Service Bulletin

Bulletin No.: 18-NA-153

Subject: Wireless Charging System Check/Phone Compatibility/Retrofit Kit Available

5067794

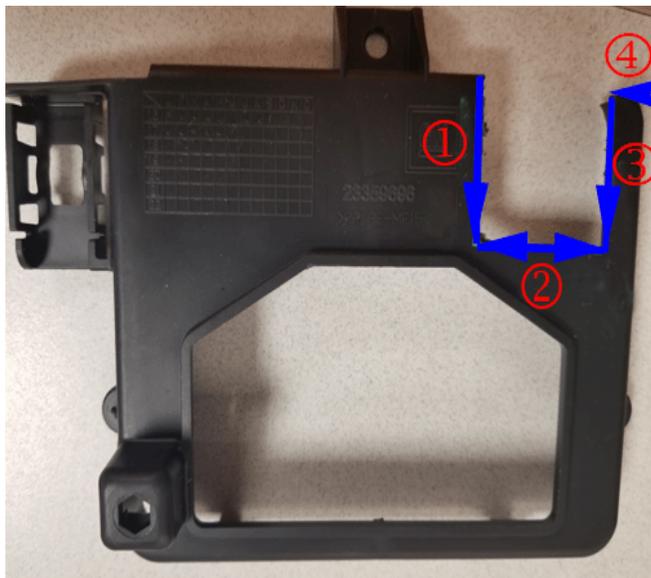
Important: The Chevrolet Colorado, Malibu, and GMC Canyon will require slight modification to install the GEN II wireless charging retrofit kit. The modifications are necessary to allow the new connector location to have proper clearance. Please reference the modification procedure below.

Chevrolet Colorado and GMC Canyon Modification Procedure

- (1) 32 mm
- (2) 30 mm
- (3) 30 mm
- (4) 11 mm

Modify the wireless charging module bracket by trimming the areas shown to allow clearance for the new module connector.

5067795

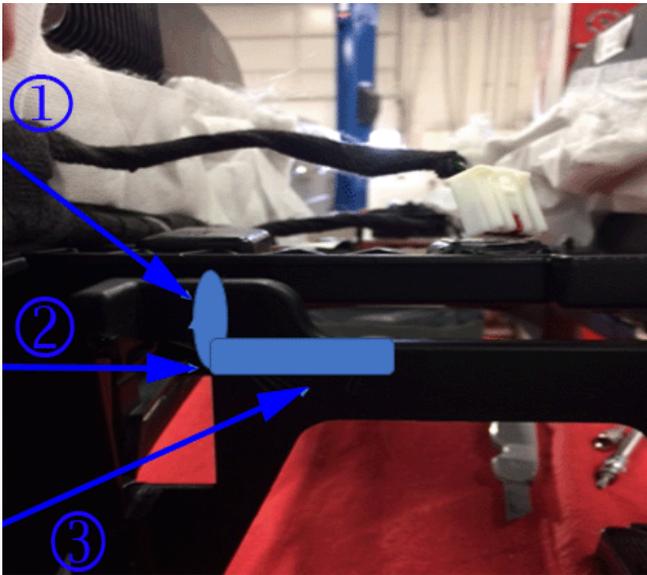
View of area where cell phone charger attaches to console. Looking from rear of console before cutting console webbing.

Note: Console is upside down in this picture.

5067796

1. Cut vertically up from existing rectangular opening.
2. Cut down approximately 5 mm, 30 mm from edge of existing rectangle.
3. Cut horizontally from rectangular opening to the prior cut that was 5 mm down.

5067797

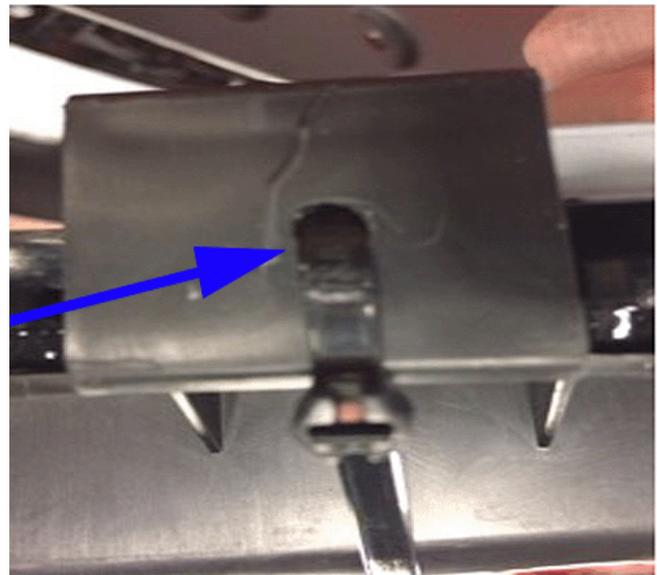
Finished console modification.

Modified area inside oval

Note: Console is still upside down in this picture.
